#### Working Party on Passive Safety

#### Regulation No. 11 (Door latches and hinges)

## Proposal for the 04 series of amendments to Regulation No. 11

### Submitted by the expert from the European Commission\*

Model A

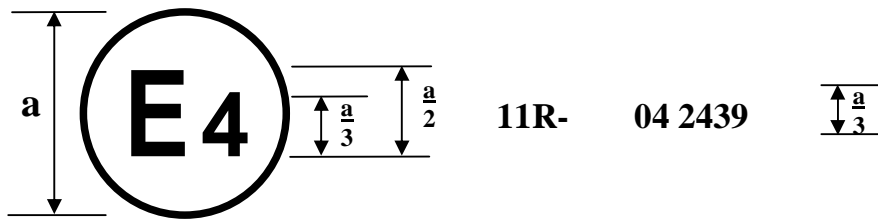
The above approval mark affixed to a vehicle shows that the vehicle type concerned has, with regard to door latches and door retention components, been approved in the Netherlands (E 4) pursuant to Regulation No. 11, under approval number 042439. The first two digits of the approval number indicate that the approval was granted in accordance with the requirements of Regulation No. 11 as amended by the 04 series of amendments.

Model B

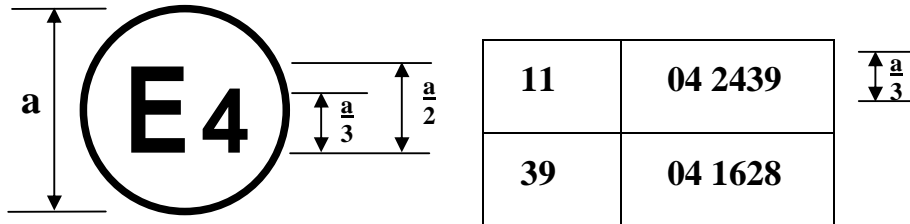
The above approval mark affixed to a vehicle shows that the vehicle type concerned has been approved in the Netherlands (E 4) pursuant to Regulation No. 11 as amended by the 04 series of amendments and Regulation No. 39, as amended by the 04 series of amendments. 1/”

**Figure 7-1**

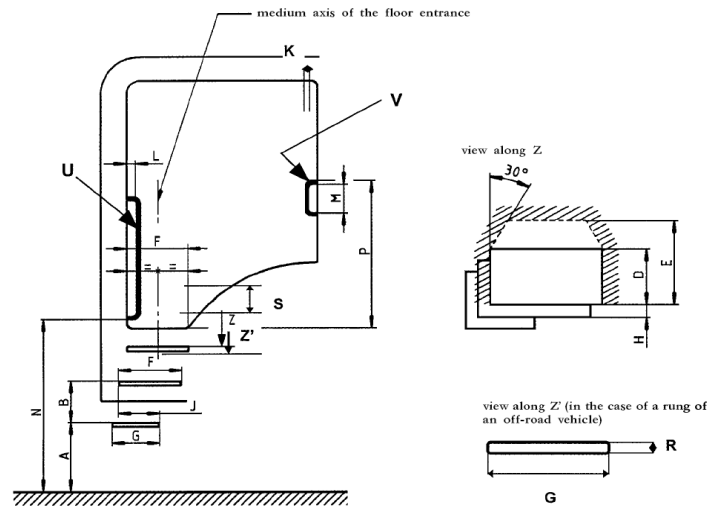
- 1. Access steps to the driver's compartment (see figure 7-1)**
- 1.1. The distance (A) from the ground to the upper surface of the lowest step, measured with the vehicle in running order on a horizontal and flat surface, shall not be more than 600 mm**

- 1.2. The distance (B) between the upper surfaces of the steps shall be not more than 400 mm. The vertical distance between two subsequent steps shall not vary by more than 50 mm. The last requirement shall not apply to the distance between the uppermost step and the cab floor.**

- 1.3. In addition, the following minimum geometrical specifications shall be fulfilled:**
  - (a) step depth (D): 80 mm**
  - (b) step clearance (E) (include step depth): 150 mm**

- (c) step width (F): 300 mm**
  - (d) width of the lowest step (G): 200 mm**
  - (e) step height (S): 120 mm**
  - (f) transversal offset between steps (H): 0 mm**

- (g) longitudinal overlap (J) between two subsequent steps in the same flight, or between the uppermost step and the cab floor: 200 mm.**
- 1.3.1. However, for off-road vehicles (see paragraph 1.1.1.) the value (F) may be reduced to 200 mm.**

- 2.1.5. The steering wheel may be considered as a handhold.
    - 2.2. The height (N) of the lower edge of at least one handrail or handhold or equivalent holding device, measured from the ground with the vehicle in running order on a horizontal and flat surface, shall not be more than 1,850 mm.

- 2.2.3. In addition, the minimum distance (P) of the upper edge of the handrail(s) or handholds or equivalent holding devices from the floor of the driver's compartment shall be:

- (a) handrail(s) or handholds or equivalent holding devices (U) 650 mm,
        - (b) handrail(s) or handholds or equivalent holding devices (V) 550 mm.

- 2.3. The following geometrical specifications shall be fulfilled:
    - (a) gripping dimension (K): 16 mm minimum 38 mm maximum,
    - (b) length (M): 150 mm minimum,

- (c) **clearance to vehicle components (L): 40 mm minimum with open door.**
